Broadland Flood Alleviation Project: Planning Application for Flood Alleviation Improvements in Compartment 25 (Gillingham Marshes, River Waveney)

Report by Senior Waterways and Recreation Officer

This report provides members with a summary of Broadland Environmental Services Ltd (BESL's) planning application proposals for flood defence improvement works at the extreme downstream end of Compartment 25 which is situated at Gillingham Marshes between the A146 road bridge and Hill Farm, Boathouse Hill on the true left bank of the River Waveney near Beccles.

COMPARTMENT 25 - PHASE 3 RIVER WAVENEY GILLINGHAM MARSHES PROPOSED E.P. INSTALLATION

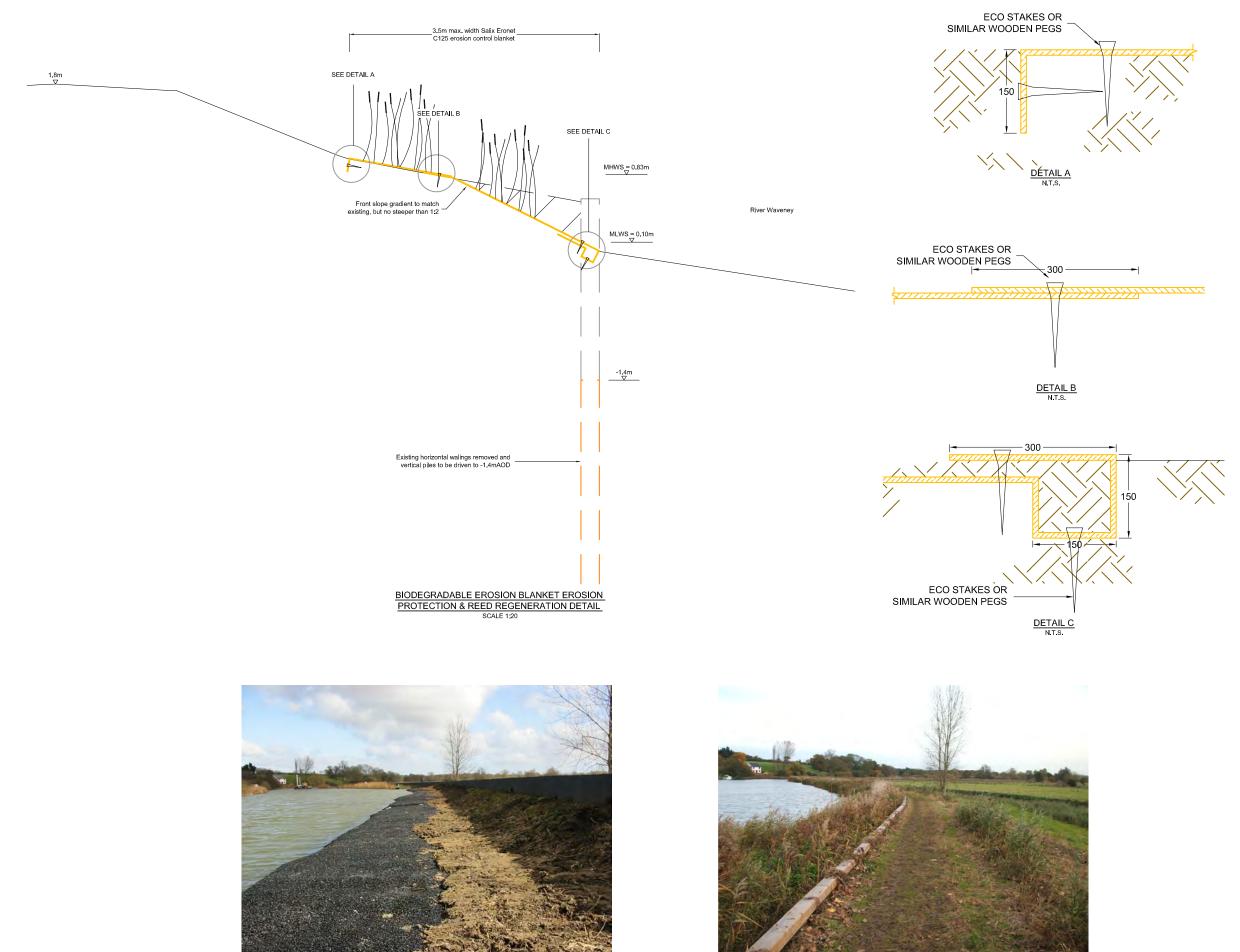
- 3.4 In this application BESL is also proposing to install erosion protection in the form of a coir (coconut fibre) blanket along a 566m length of the bank after it has been reprofiled. This design is shown in detail on the plans at Appendix 1. This reach of the river can be very busy with motorboat traffic having to navigate through racing sailing vessels from the Beccles Amateur Sailing Club (BASC) which is situated opposite the section of bank in question. The installation of coir matting therefore gives rise to some concerns regarding the potential for vessels to hit the bank and damage the matting by getting it fouled in their propellers.

- While the submission of this application is to be welcomed as it will allow for the completion of the flood defences in the Compartment and result in the removal of piling which is already causing a hazard to navigation, there are some concerns about the ability of the erosion protection proposed in the application to withstand boat impacts. Experience from some of the other compartments where BESL has installed bitumen matting erosion protection is that boats can get caught on the matting and unravel sometimes long lengths of it from the reprofiled bank that it is protecting. Indeed, on the Waveney itself there have been a number of incidents of vessels getting caught on matting installed on the true right bank between the BASC and Stanley Carr reach. Coir matting of the type shown in the application is less robust than bitumen matting and as this section of bank has a history of being hit by motor boats officers consider there is a real risk that the matting will be damaged by boat impact.

- 5.2 Members' comments are therefore welcomed as to whether it would be appropriate to require an additional pre-commencement condition dealing with the future management of the navigation. For example a requirement for the submission and agreement of a mitigation plan dealing with any problems with the erosion protection, failure of the reprofiled edge, poor vegetation establishment and installation and removal of appropriate channel marking. Members' comments are also sought on the issue of the use of buoys for mooring by the BASC.
